**Falcon Place (SUB 12-01)  
Submission for Completeness**

3J Consulting acts on behalf of OLC 14, LLC. and JT Smith Companies in preparing this letter to address the incompleteness notification released by your office on December 13, 2012 relating to the Falcon Place Subdivision. This letter has been prepared to both address each of the items listed within the City's incompleteness determination and to describe the changes which have occurred to the preliminary plans and submission materials.

**Project Name: Falcon Place (SUB 12-01)**  
**Project No: 12093**  
**RE: Stormwater Management Memorandum**

**C2.0**

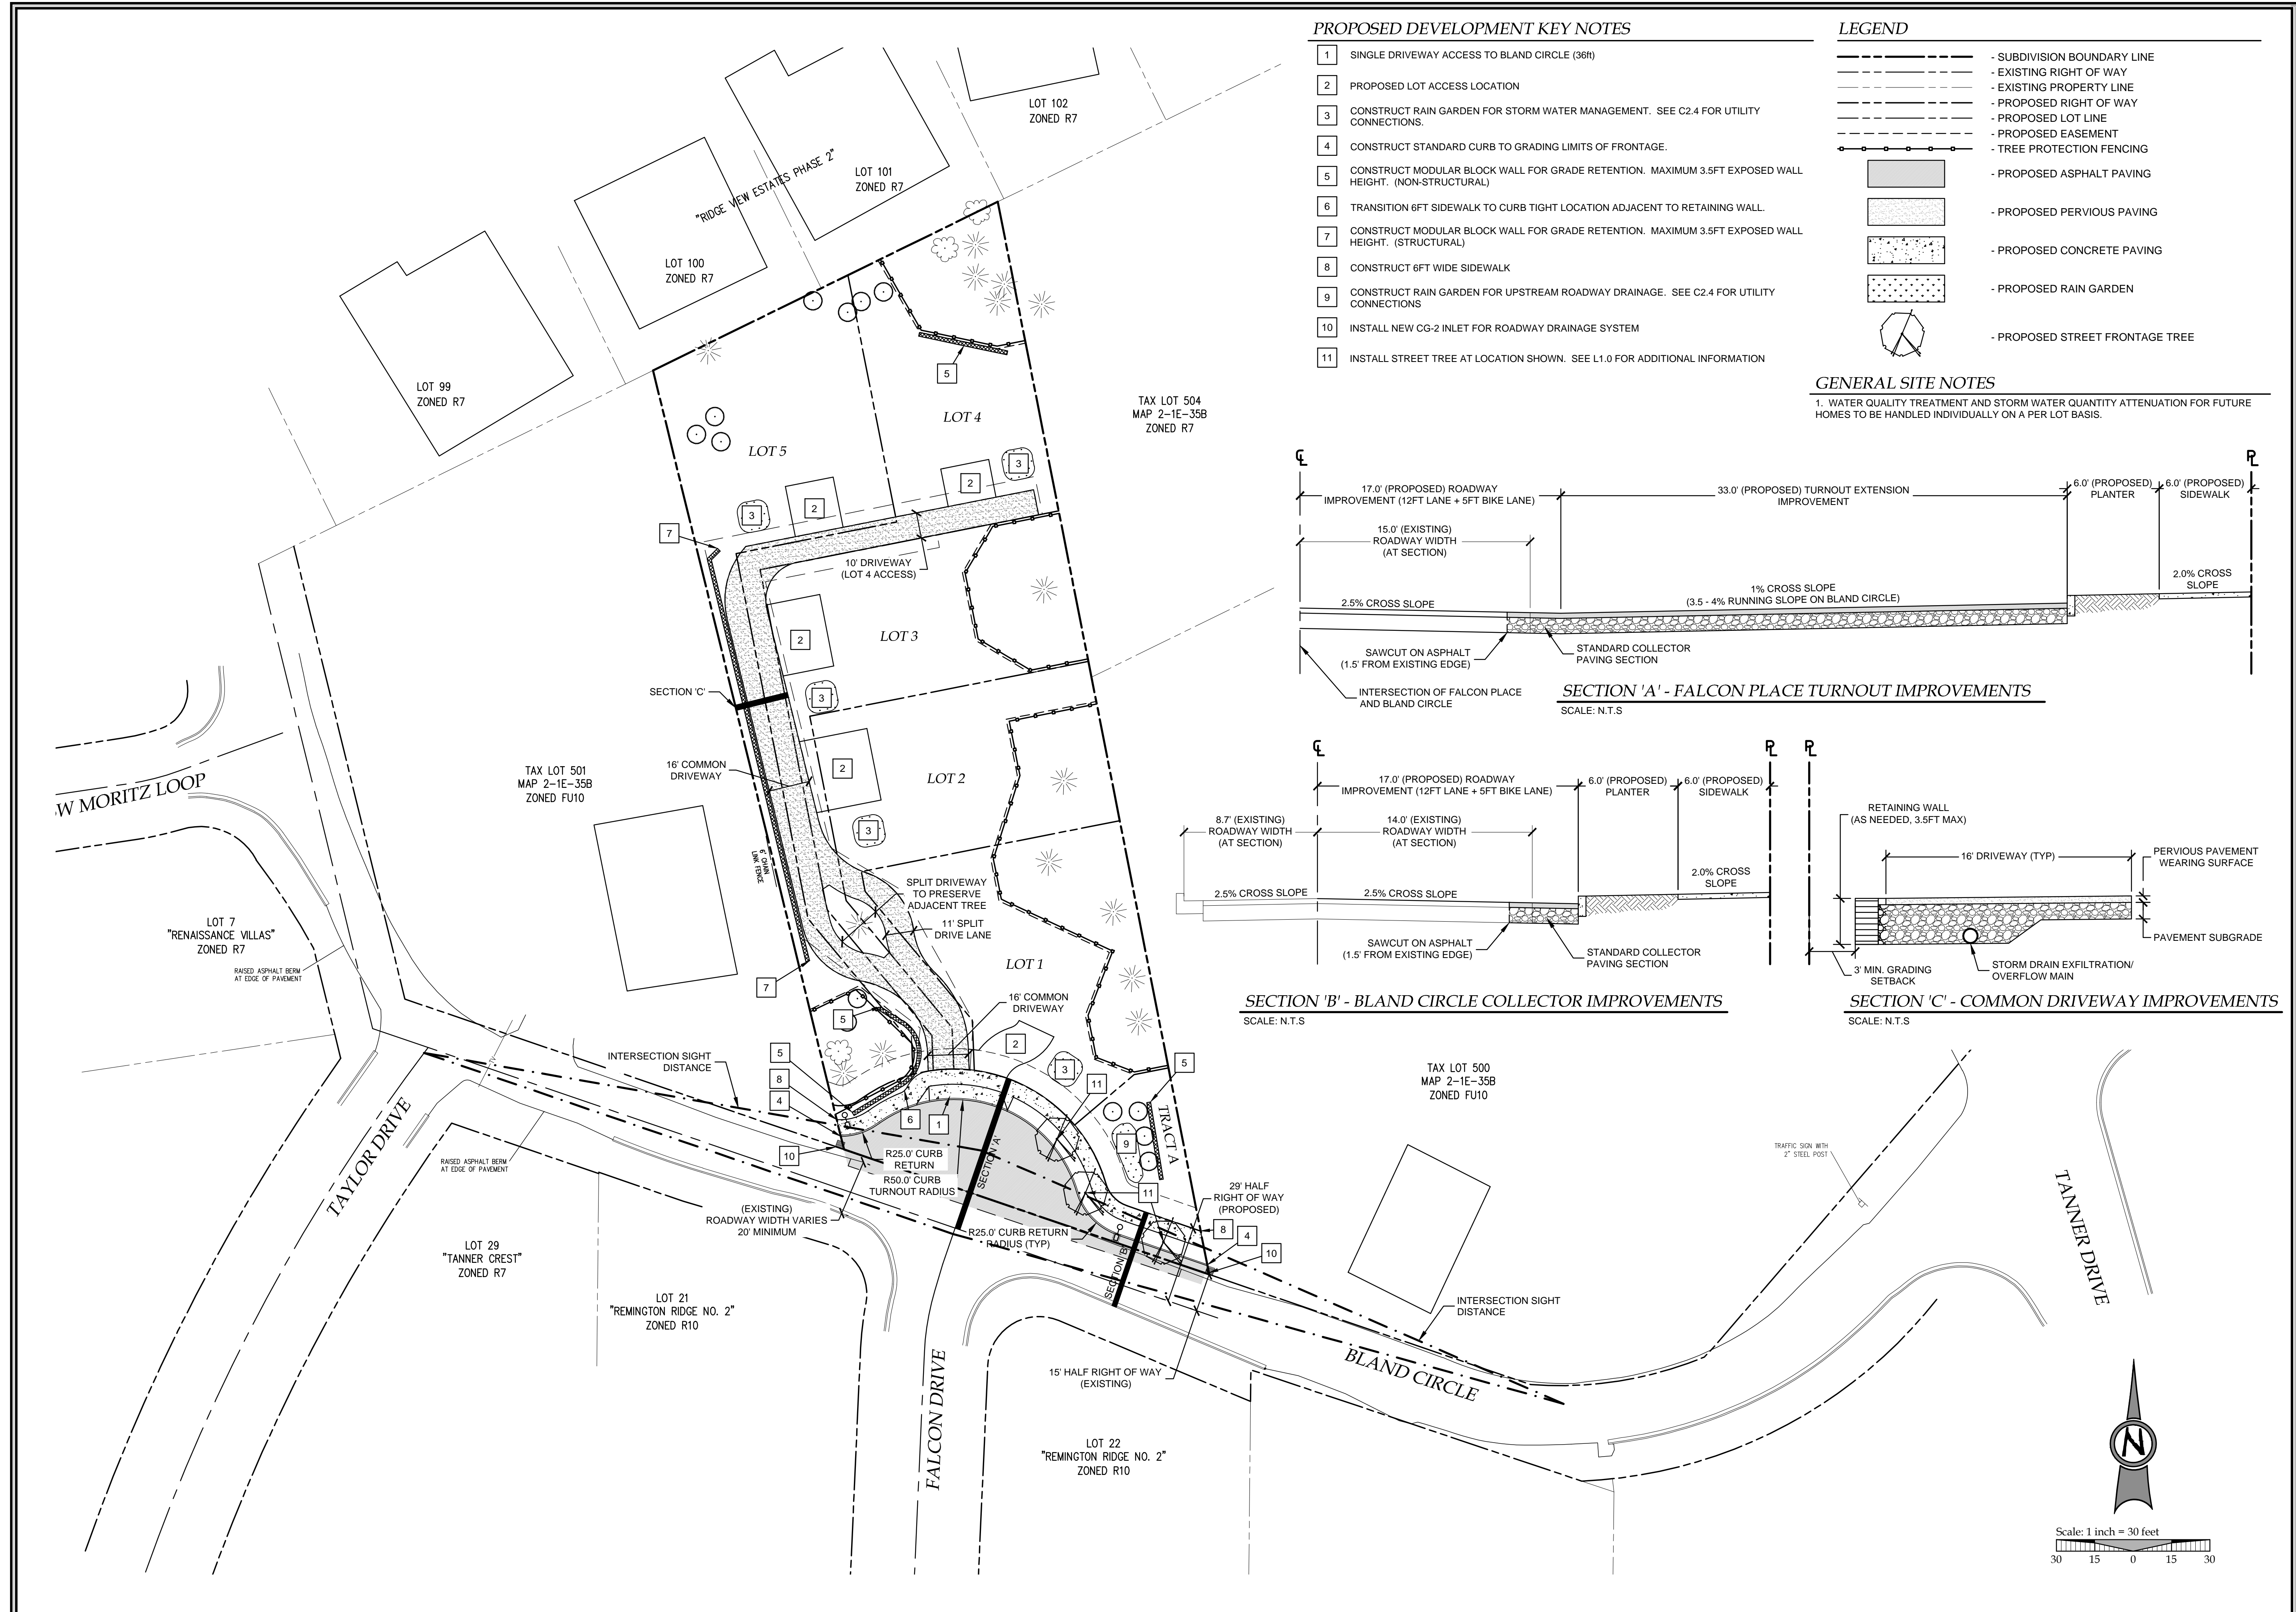
Code Reference	Comment	Design Change, Plan Modification or Description of Resolution
<b>Planning Comments</b>		
85.160(D)(4)	No legal description on tentative plan	A legal description has been added to the tentative plat.

85.160(D)(5)	No name of owner, developer, and engineer on tentative plan	Name of owner, developer, and engineer have been added to the tentative plat.
85.160(E)(1)	Clearly show width of existing street and ROW	Widths of ROW and existing streets have been shown on the tentative plat and site plan.

85.160(E)(8)	Show Zoning both on and off-site.	Zoning designations have been added to the tentative plat for both the subject property and the adjoining properties.

**C2.2**

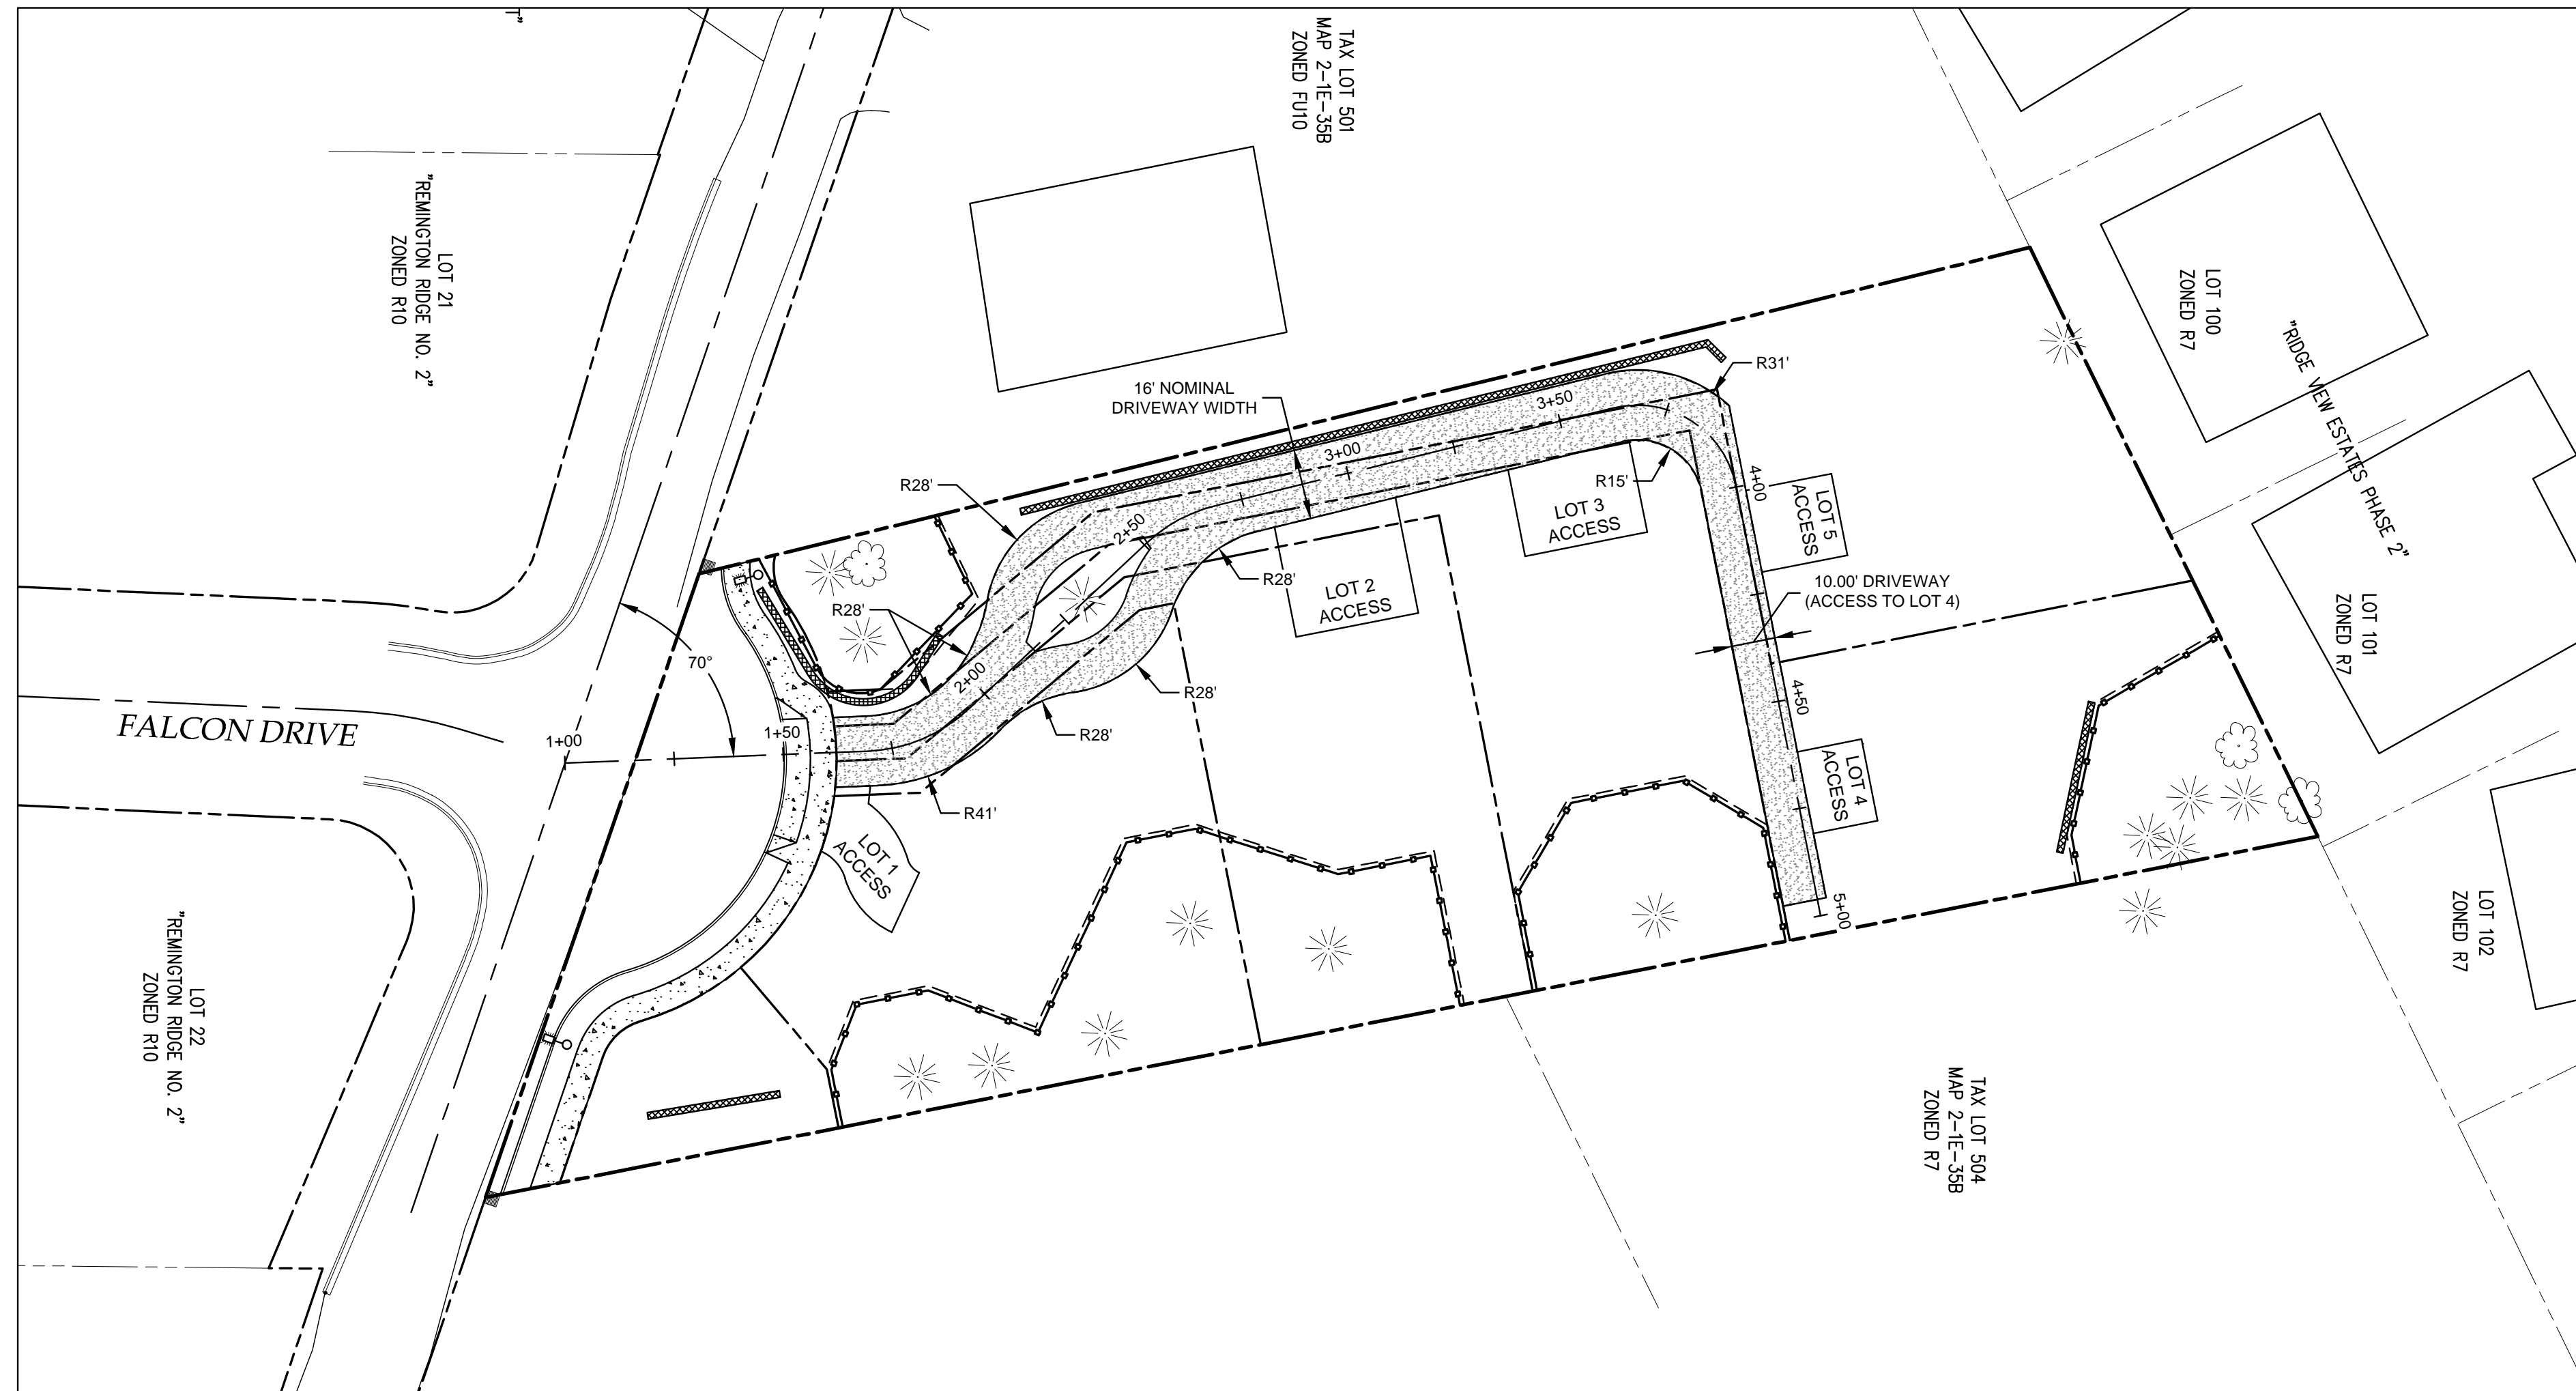
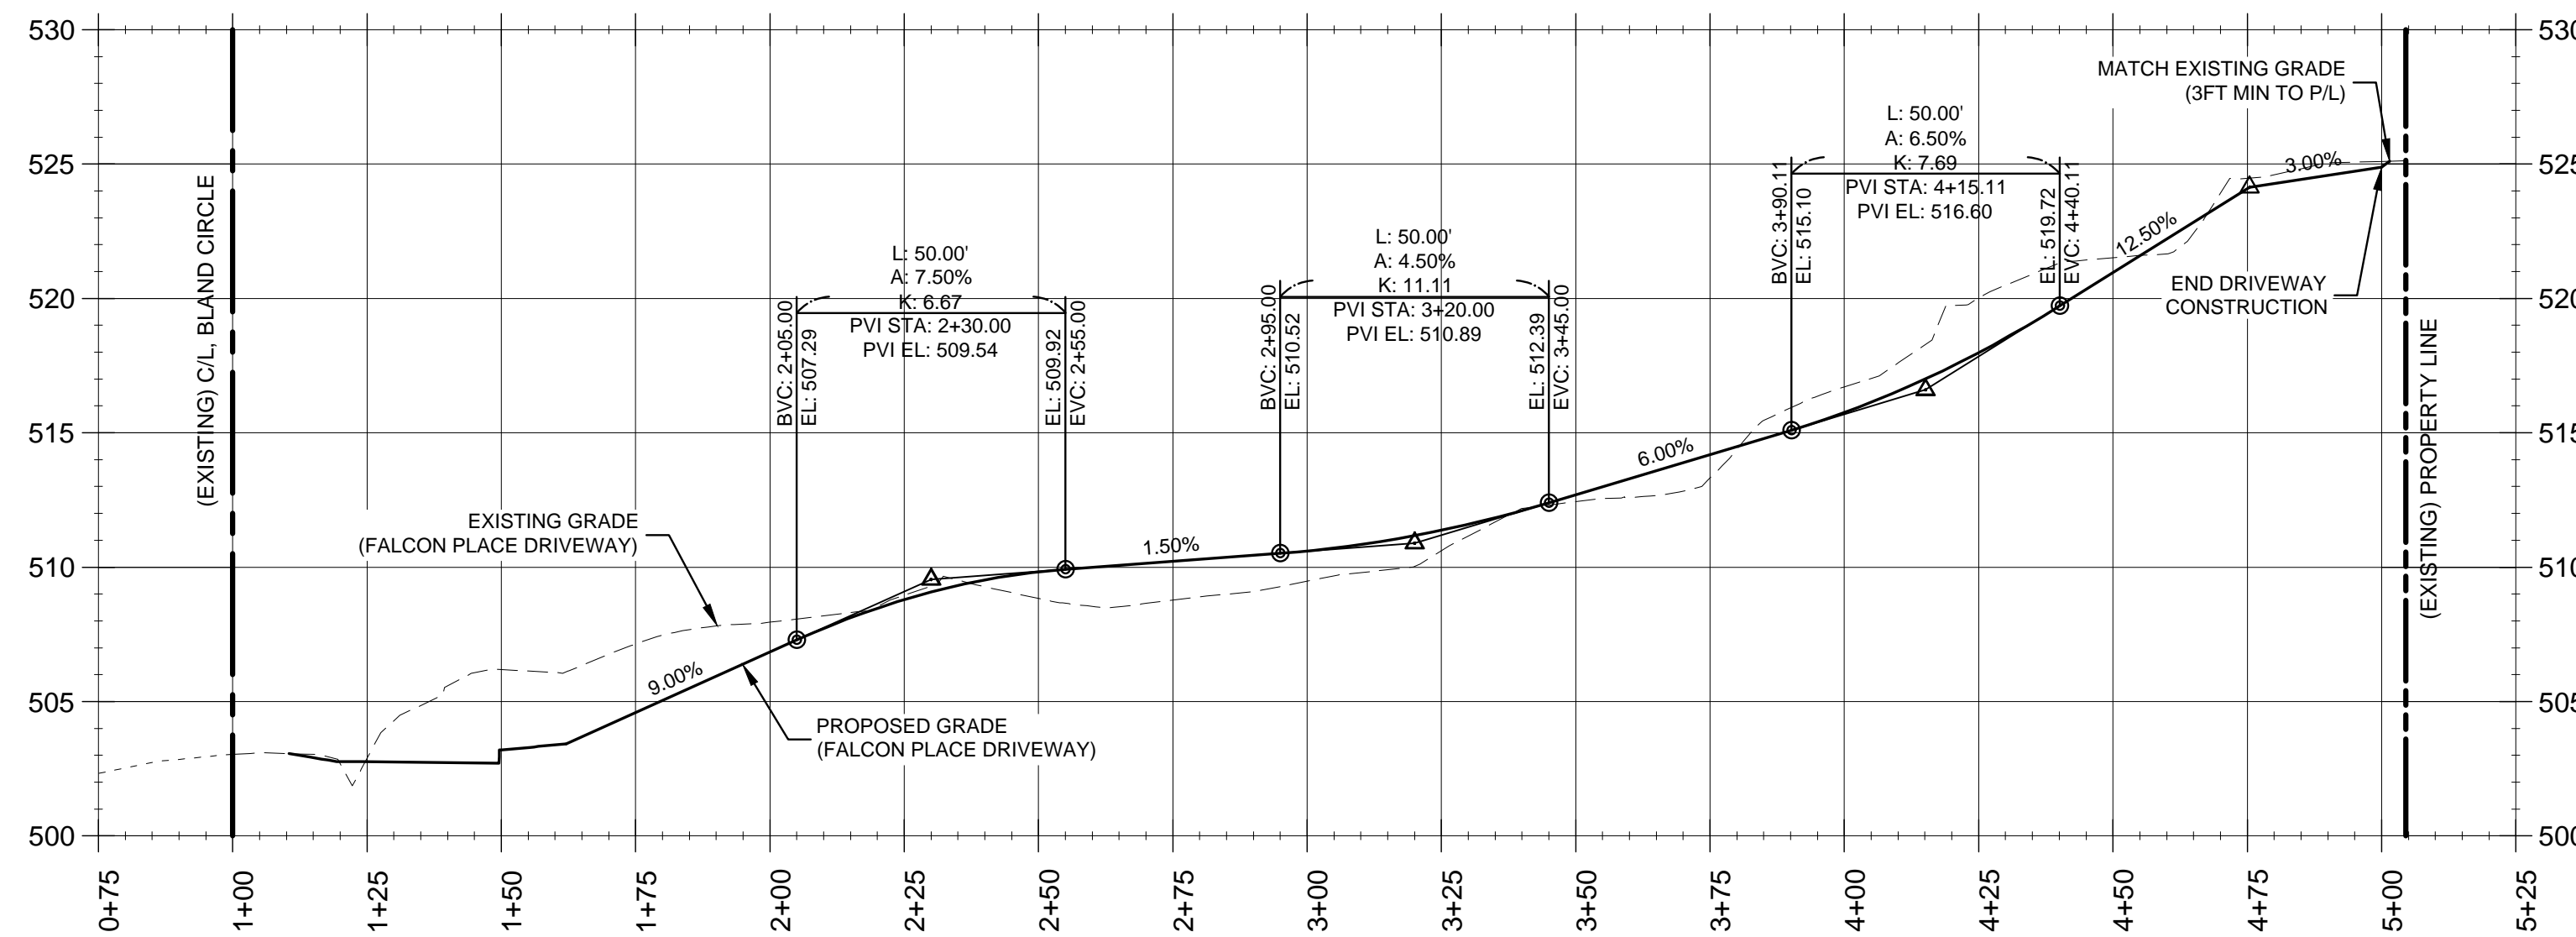
85.170(B)(1)	Center line profiles with extensions shall be provided beyond the limits of the proposed subdivision to the point where grades meet, showing the finished grade of streets and the	Centerline profiles for the proposed public street and private driveway have been provided within the revised plan set. These drawings are shown on sheet C2.2 of the plan set.
